**UNITED STATES OF AMERICA
BEFORE THE
FEDERAL ENERGY REGULATORY COMMISSION**

North Dakota Public Service Commission)	
Montana Public Service Commission)	
Arkansas Public Service Commission)	
Mississippi Public Service Commission)	
Louisiana Public Service Commission)	
Complainants,)	Docket No. EL25-109-000
)	
v.)	
)	
Midcontinent Independent System Operator, Inc.,)	
Respondent)

**MOTION TO INTERVENE AND COMMENTS OF
THE MISO INDEPENDENT MARKET MONITOR**

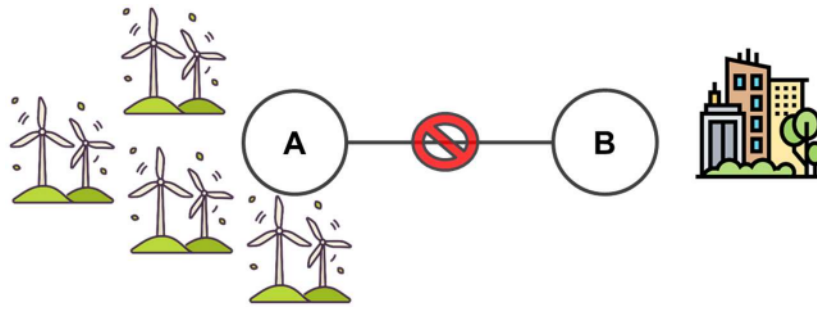
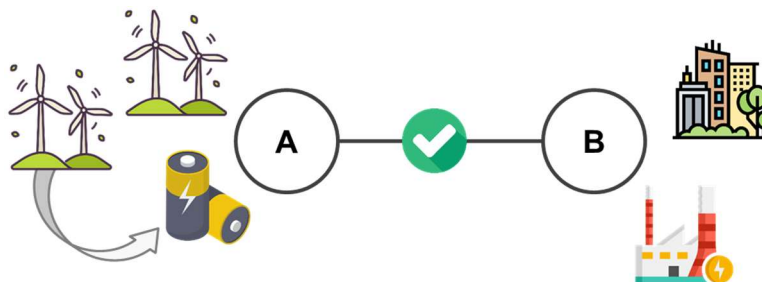
For these reasons, developing a Future with an excessive amount of intermittent renewables and underestimating the quantity of dispatchable storage and conventional resources will generally inflate the transmission needs of the system. The figure below illustrates the difference in transmission needs and congestion that can arise in different futures. The first

illustration depicts a system with a large quantity of remotely cited intermittent renewable resources. When the output of these resources peaks, it loads the transmission paths between location A and B in this illustration, resulting in transmission overloads. This illustration is consistent with MISO's Future 2A that is the basis for Tranche 2.1.

Illustration B depicts a more realistic view of MISO's future system, which is likely to include a much heavier reliance on storage resources and dispatchable generation than is included in Future 2A.

This illustration shows a scenario that would produce substantially lower transmission flows and associated congestion between A and B because of: (i) lower quantities of intermittent renewable resources, (ii) greater quantities of storage resources that can charge when the renewable resource output peaks to take the loading off of the transmission system, and (iii) the presence of dispatchable resources whose output can be adjusted up and down by MISO to reduce the transmission flows and manage congestion.

This difference between these types of Future scenarios is significant because our evaluation found that the latter scenario is more consistent with the plans of MISO's members.

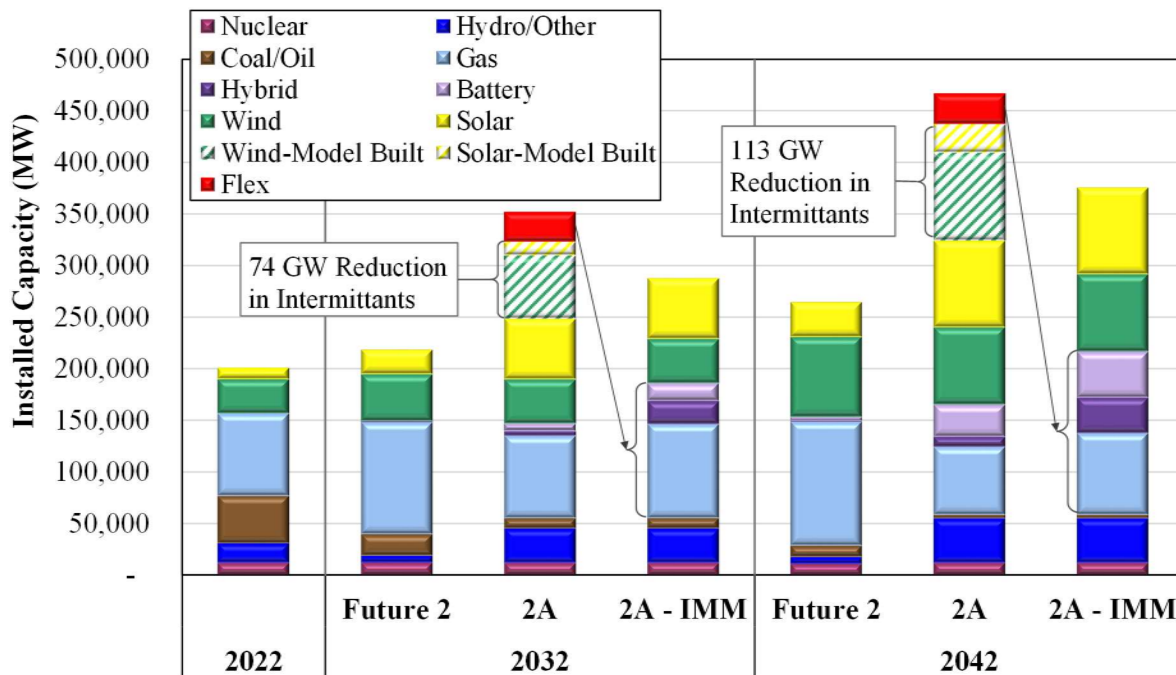
- MISO modeled a system-wide carbon constraint that was inconsistent with the carbon policies and targets of its states and members. Modeling this constraint restricted the model's ability to properly forecast that generators will invest in dispatchable conventional resources in states with no carbon legislation or targets. MISO's capacity and energy markets will provide strong incentives to invest in such resources, which we see reflected in MISO's interconnection queue.

These issues caused EGEAS to forecast that nearly all new model-built resources will be intermittent renewable resources and virtually no new conventional dispatchable resources. The fact that the EGEAS model did not recognize the attributes and reliability value of different types of resources caused it to forecast a portfolio that would not satisfy MISO's energy adequacy needs. Therefore, after MISO developed the capacity expansion plan, it added 30 GW of "Flex" resources that are non-emitting dispatchable resources.

The fact that the Flex resources were added *after* the capacity expansion model ran and attempted to optimize the investment in new resource invalidates the results of the model. A valid analysis would require that MISO iterate to add the Flex resources as an input to the model and then re-run EGEAS to determine a new quantity of model built resources. We believe this would have reduced the forecasted intermittent resources by a quantity much larger than the quantity of Flex resources since the capacity availability and reliability value of dispatchable Flex resources would be much higher than the intermittent resources.

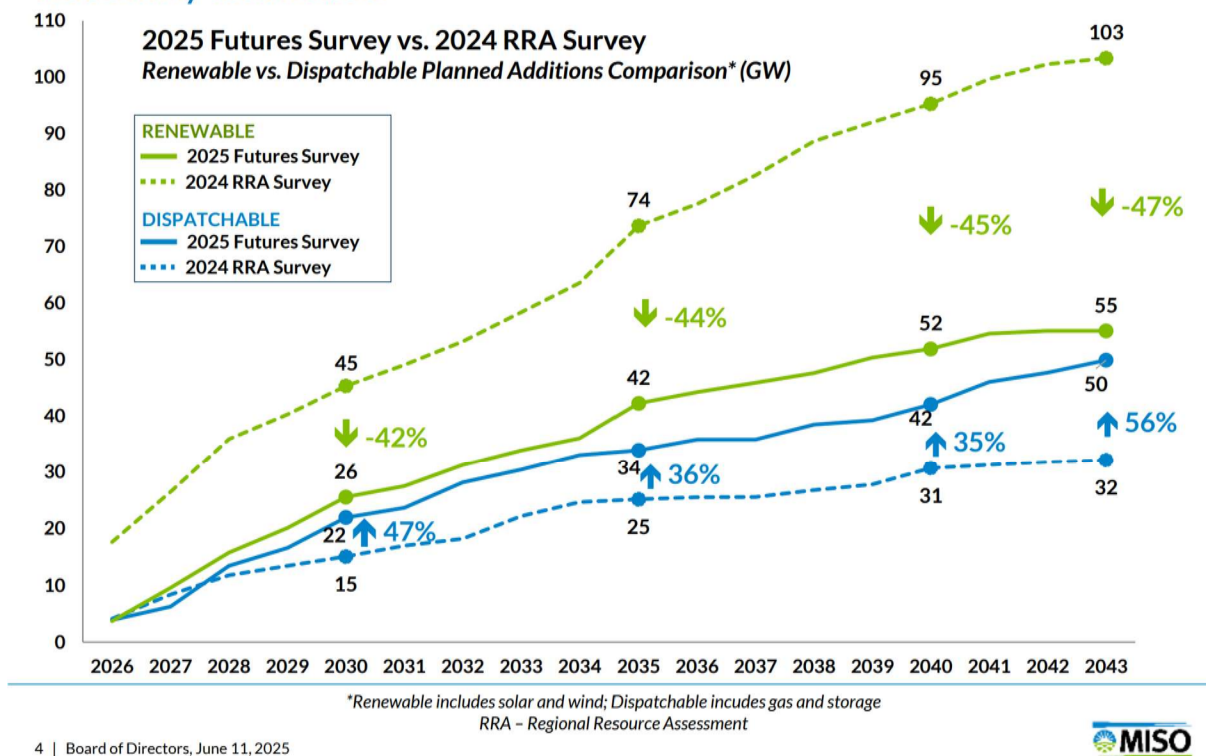
As shown in the figure below, we estimate that building dispatchable resources to meet MISO’s reliability and energy adequacy needs would displace 113 GW of intermittent renewable resources and reduce the costs of Future 2A by \$92 billion.

Importantly, the IMM’s modification of Future 2A would satisfy all of the States’ and member utilities carbon goals by 2042, as well as the energy adequacy needs of the MISO system. The IMM Future 2A portfolio is also much better aligned with the generation in MISO’s interconnection queue and the IRPs of MISO’s members.

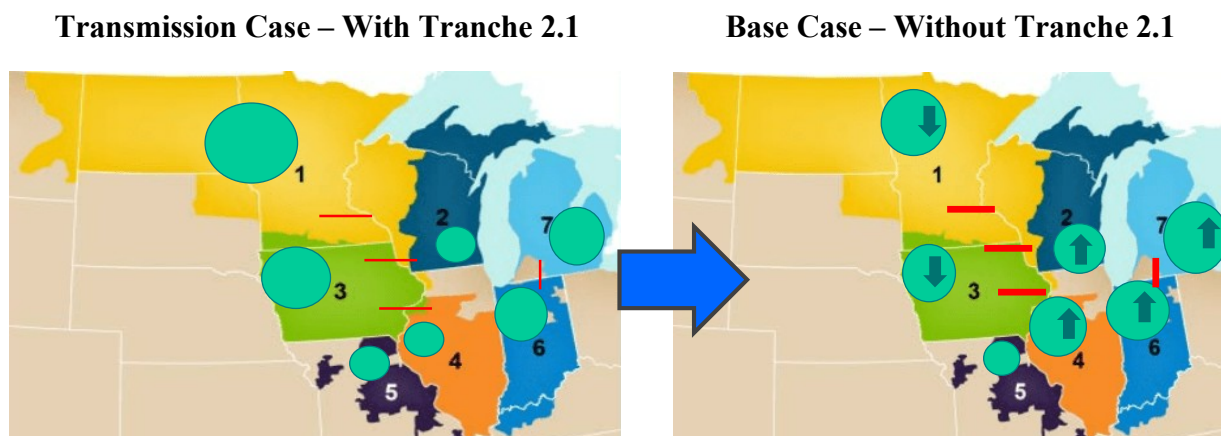
The differences in resource entry and siting in these two cases must be estimated because they will affect MISO's transmission needs and congestion patterns. Therefore, the benefit estimates will not be accurate if MISO does not estimate the effects of the transmission investments on participants' resource investment and siting decisions. This is illustrated in the figure below where the green circles represent the quantity of new resources and the red lines represent the constraints (with the thickness indicating the severity of the constraints).

This illustration shows why the benefit analyses must recognize that new transmission will change energy and capacity market signals – *because less transmission will shift resources closer to load*. The left illustration depicts the distribution of new resources under Future 2A, showing a larger share of resources located farther from load and utilizing the reinforced transmission network to deliver its energy output to the larger load centers. Assuming this fixed distribution of new resources under Future 2A leads to relatively large transmission benefits from Tranche 2.1 associated with reducing congestion, reducing transmission losses, reducing the need to build additional generation to replace capacity that is not deliverable, and mitigating reliability issues associated with transmission violations.

The right illustration shows how the location of resources is likely to change, as indicated by the green arrows and the changing size of the green circles. This illustration shows that the new resources will generally shift closer to load if less transmission is built. This will occur because both investment and retirement decisions will be affected by the change in market signals and capacity requirements. Importantly, this shift in resources will reduce or eliminate many of the benefits MISO estimated because it will reduce:

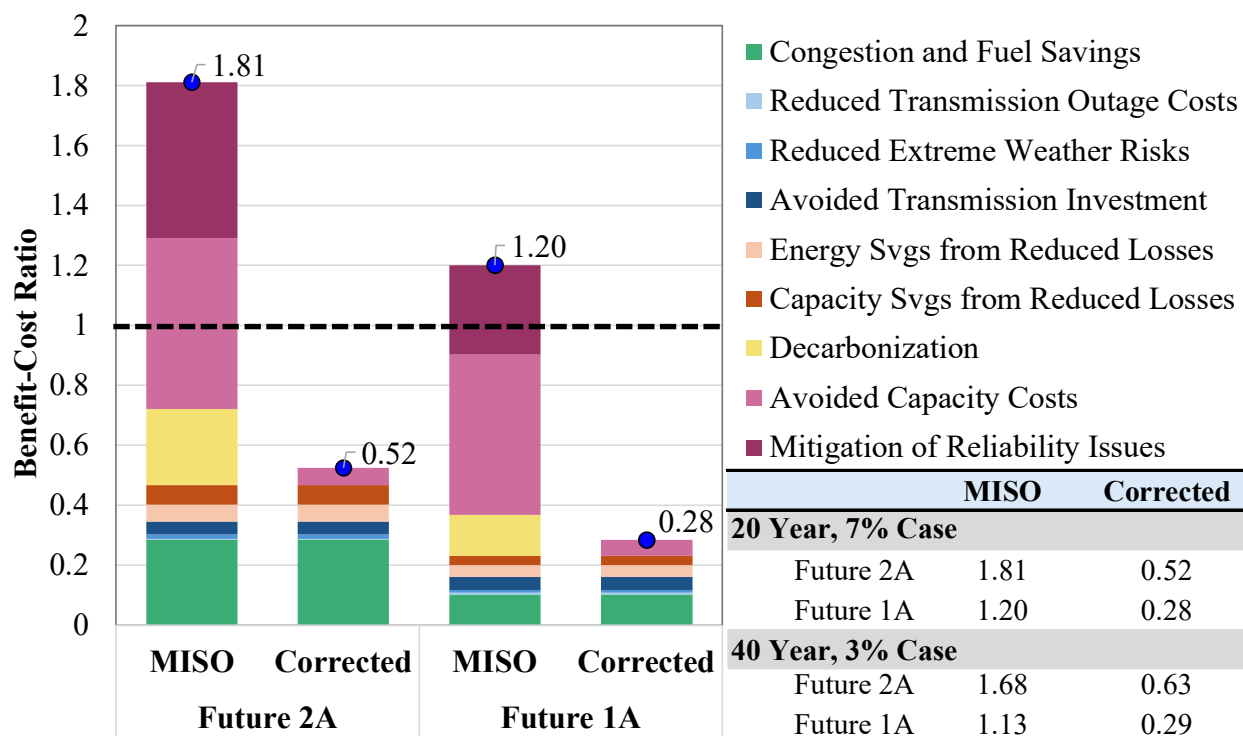
These three adjustments, although they do not completely correct the results of MISO’s business case for the flaws discussed in these comments and in the Complaint, produce very different benefit-cost ratios for Tranche 2.1. The figure below summarizes and compares the benefit-cost results produced by MISO compared to our corrected results. MISO’s results are produced over two timeframes – 20 and 40 years, and with two discount rates – 3 percent and 7 percent. The stacked bars on the left side of the figure show the contribution of each category of benefits to the benefit cost ratio in the 20-year 7% discount rate cases. MISO measured its benefits against the Future 2A scenario and the Future 1A scenario, which assumes lower levels of renewable resources and loads. We show the benefits for both scenarios. The inset table in the lower right also summarizes the benefit-cost ratio results in the 40 year 3% case.

This figure shows that even if one only corrects the three categories of benefits discussed in our comments above and specifically identified by Dr. Hogan and the Concerned Commissions, the 20-year benefit-cost ratio falls to 0.5 for Future 2A and 0.3 in Future 1A. These ratios rise only marginally in the 40-year 3% case.
